The Graduate Austin

Design Commission

December 11, 2023

Working Group Recommendations 11/8/2023

proposed guadalupe street section facing south

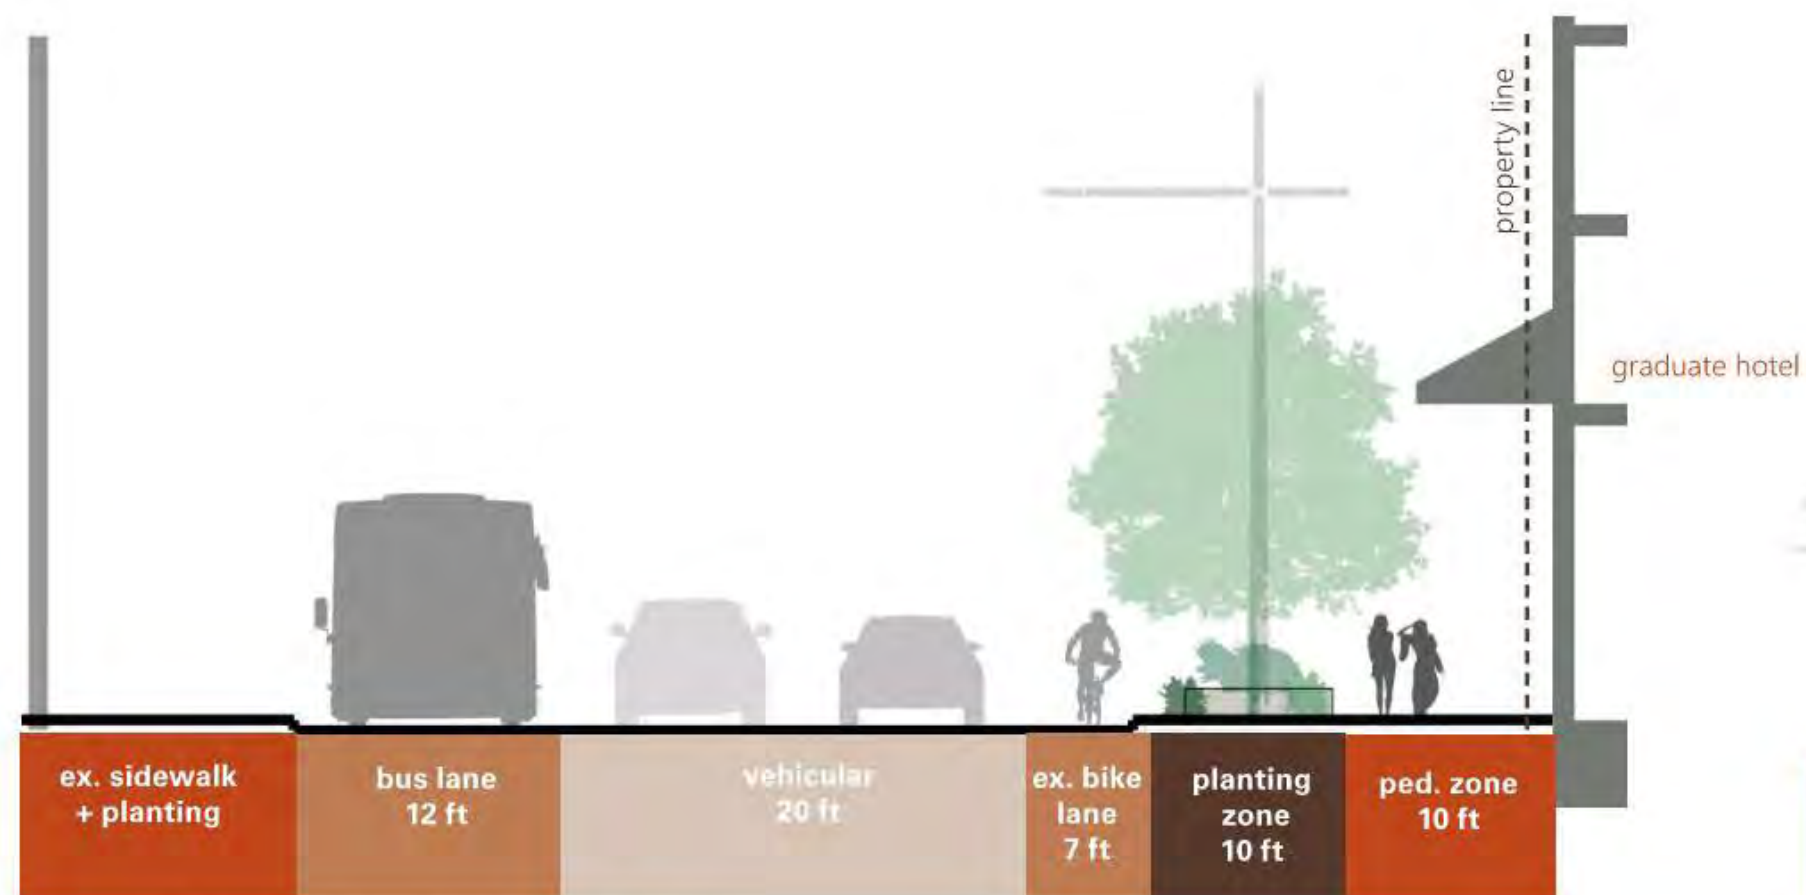
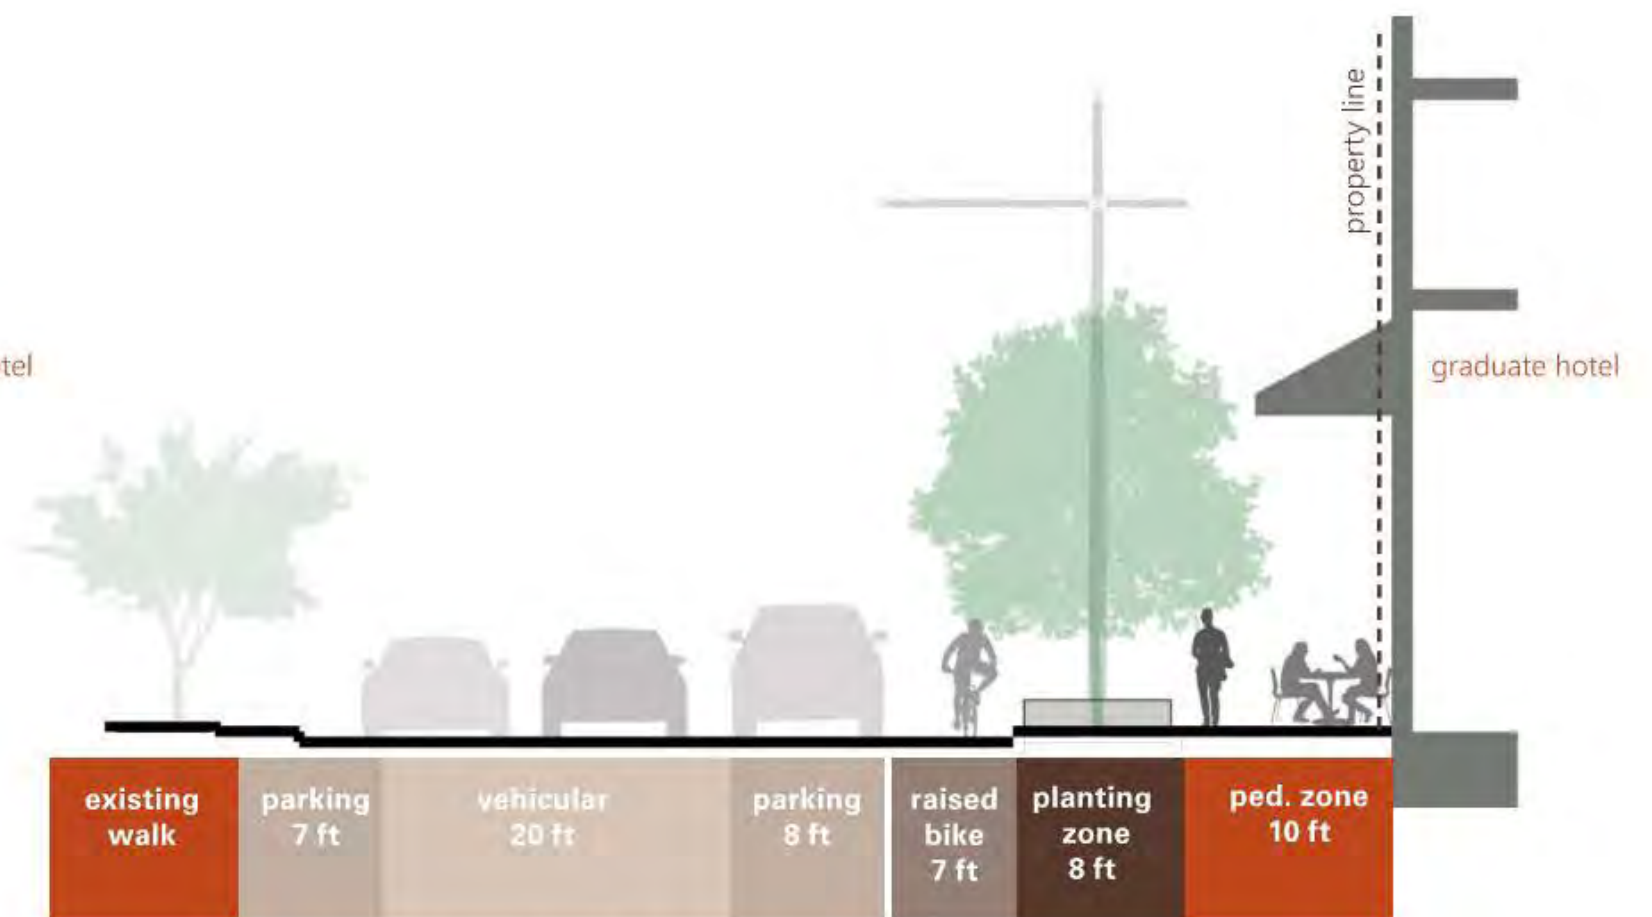
Urban Design Guideline	Working Group Recommendation
PZ 10: Provide an Appropriate Amount of Plaza Seating	Refer to the recommendations in the design guidelines to provide for a variety of seating locations which accommodate the needs of various sitters.
PZ 14: Provide Food Service for Plaza Participants	No direct food service or outdoor sitting area directly related to street plaza. Applicant is encouraged to provide more connectivity to first floor activated use.
PZ 15: Increase Safety in Plazas Through Wayfinding, Lighting and Visibility	Provide more information on wayfinding that would direct public to upper level terraces. Access from hotel lobby to F&B for person's with disabilities not clear. Applicant encouraged to show route for clarity.
B 2: Provide Multi-Tenant, Pedestrian-Oriented Development at the Street	Only small portions of the frontage along San Antonio and Guadalupe have access to tenant spaces. The chairs and tables along San Antonio do not have direct access to hotel lobby. Hotel lobby doesn't indicate any active uses to support the table/chairs. Applicant is encouraged to activate the frontage along San Antonio and Guadalupe as much as possible.
